SERVICE BULLETIN

APPLICABILITY: 2013MY BRZ

NUMBER: 09-54-12R

SUBJECT: High-Pitched “Chirp,” “Squeak” or “Cricket”
 Sound from the Engine

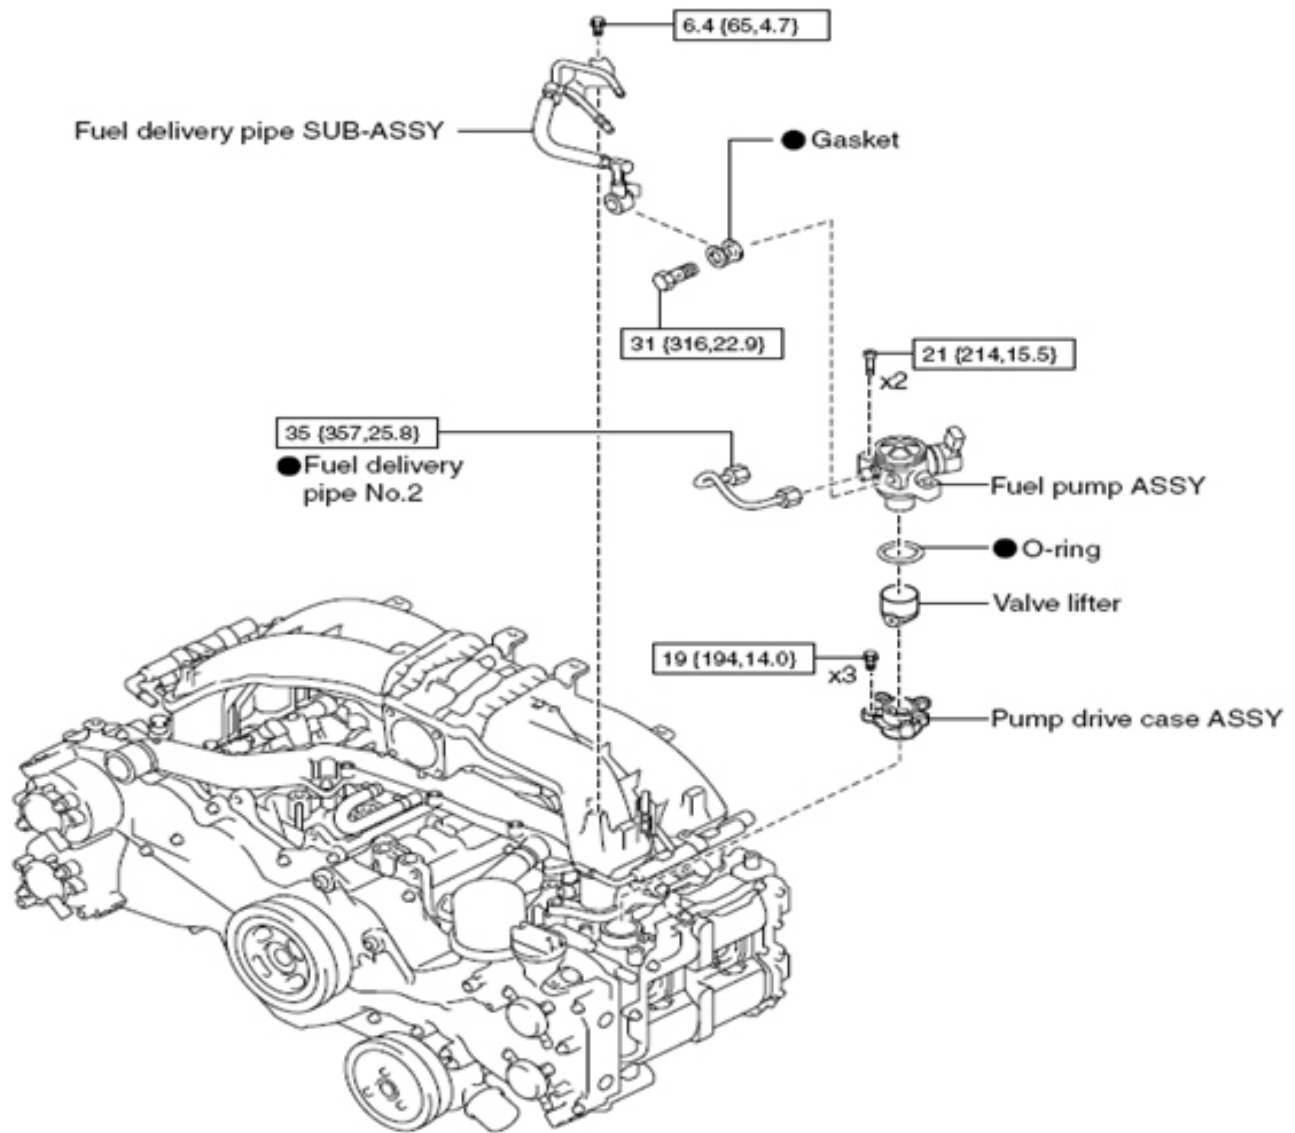
COUNTERMEASURE	VIN NUMBER	PRODUCTION DATE
1) Increase of clearance for sub-chamber fuel passage	D*607798	Mid-February, 2013
2) Shape change of plunger stopper
